# RICE POND VILLAGE

## Chapter 40B

## Neighborhood and Community Public Comments

Steve Stearns | Wed, Jan 10, 2024 | Board of Appeals Public Hearing

# Taking The Trash Out

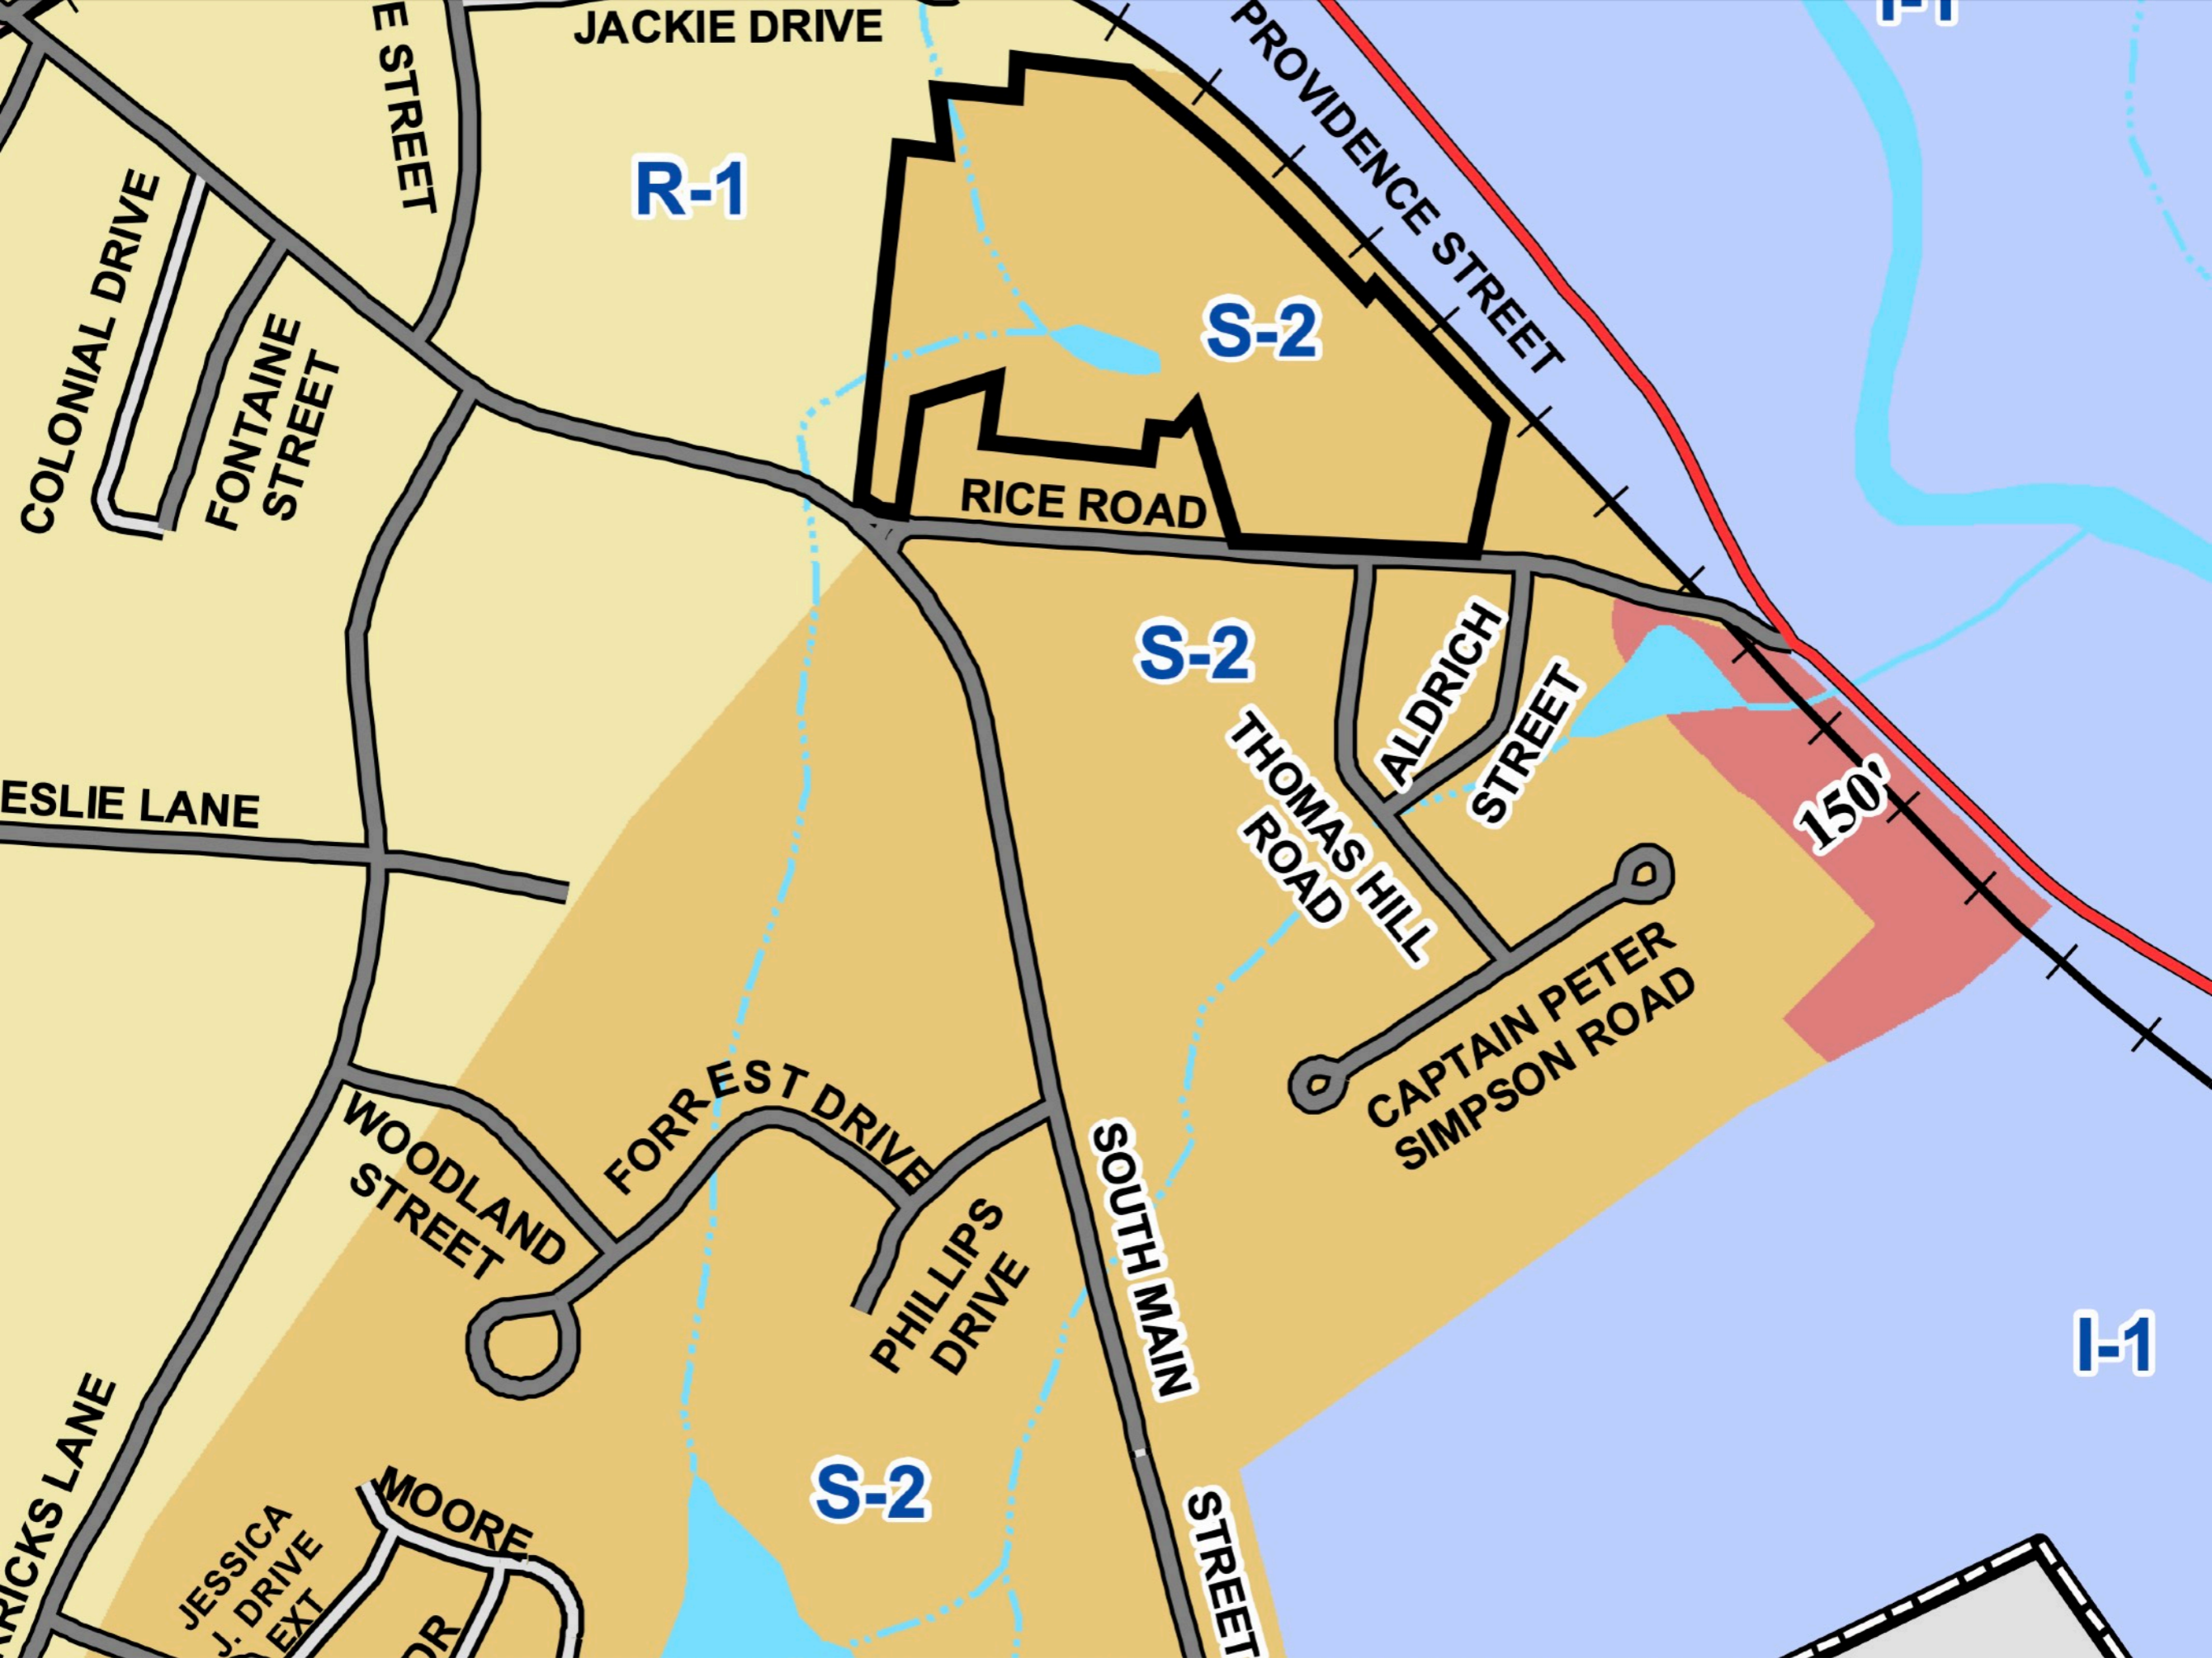
**UNPROTECTED  
RR XING**

**LESS THAN  
A MINOR ROAD  
[ RATED FOR 0-20  
DWELLING UNITS ]**

**SINGLE  
POINT OF  
ACCESS**

**INTERSECTION IMPROVEMENTS  
REQUIRED**

**UNPROTECTED  
RR XING**

**LESS THAN  
A MINOR ROAD  
[RATED FOR 0-20  
DWELLING UNITS]**

**SINGLE  
POINT OF  
ACCESS**

**INTERSECTION IMPROVEMENTS  
REQUIRED**

# Sample Building Elevation

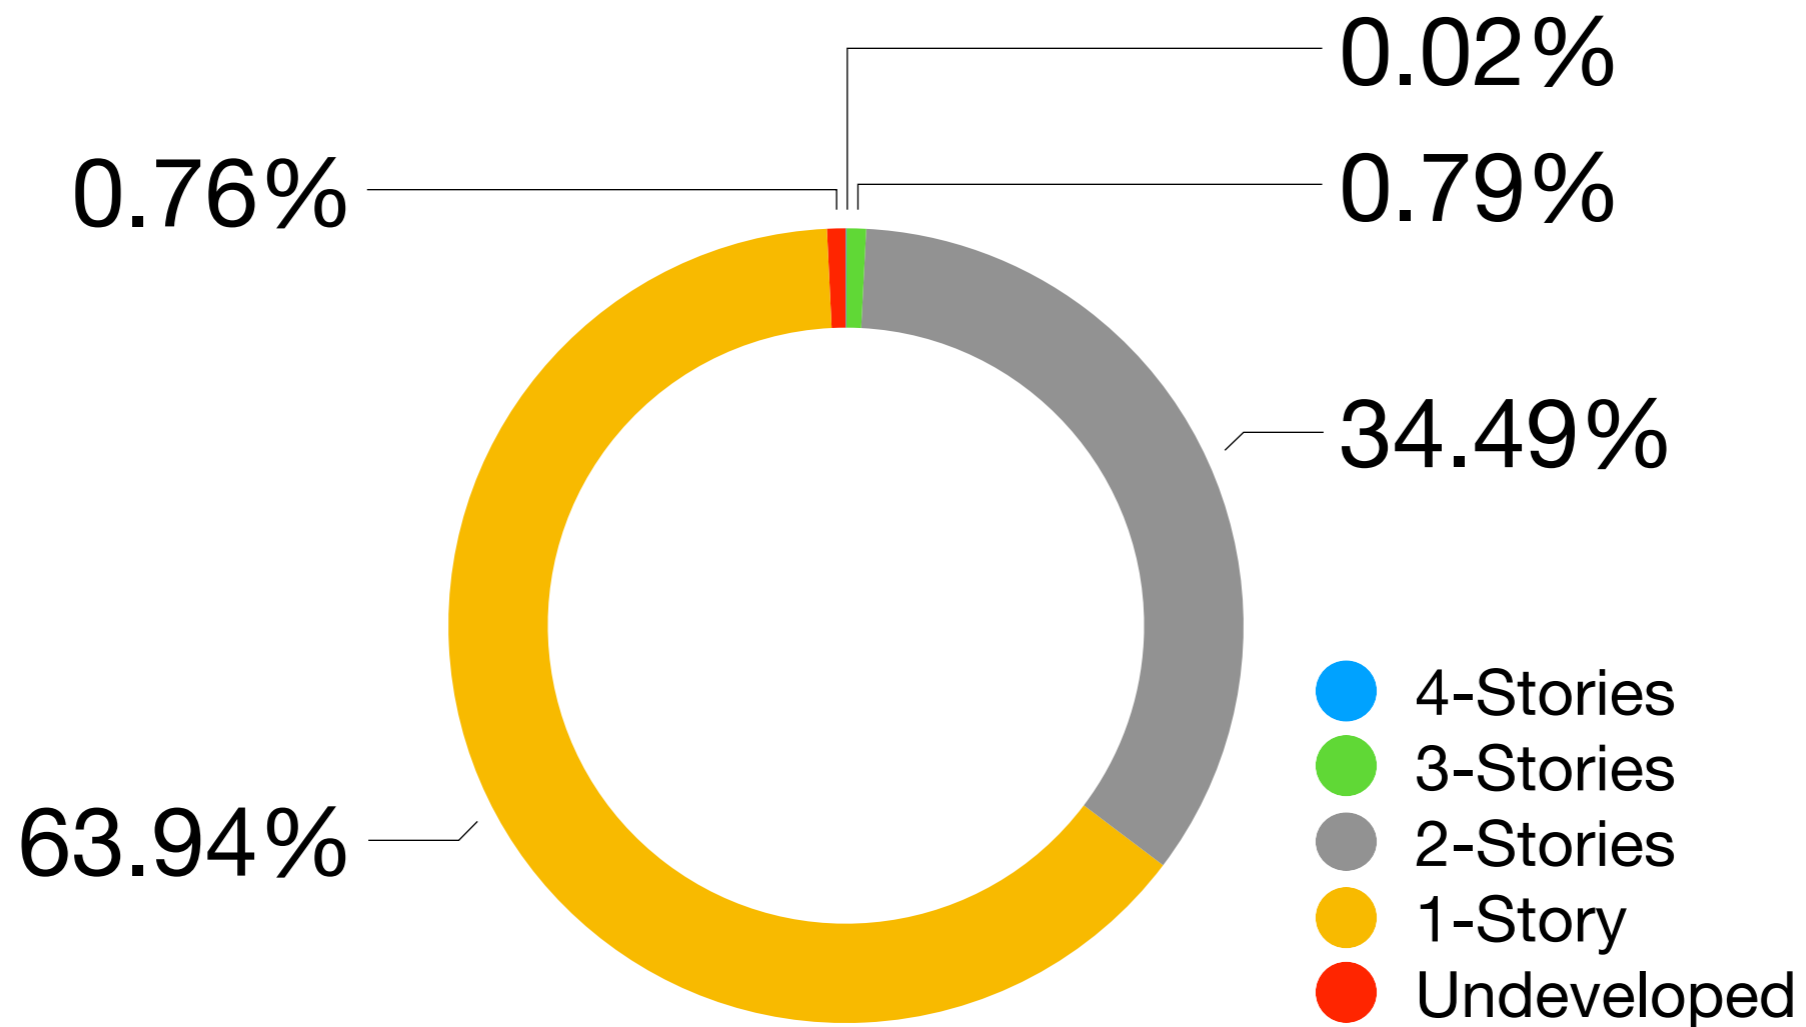
Wait, is this a 4-story building with **5 stories worth of windows**? In a Suburban II zoning district with a maximum building height of 30 feet, the **roof peak stands at a towering 65 feet and 6 inches**.

<b>Min. Lot Max. Bldg. Area</b>	<b>Min. Lot Frontage</b>	<b>Min. Yds. Front/Side/ Rear</b>	<b>Max. Coverage</b>	<b>Max. Height</b>
40,000* sf ( 15,000 sf )	150 ft	25 ft / 10 ft / 10 ft	30%	30 ft
			<b>?</b>	<b>65 ft 6 in</b>
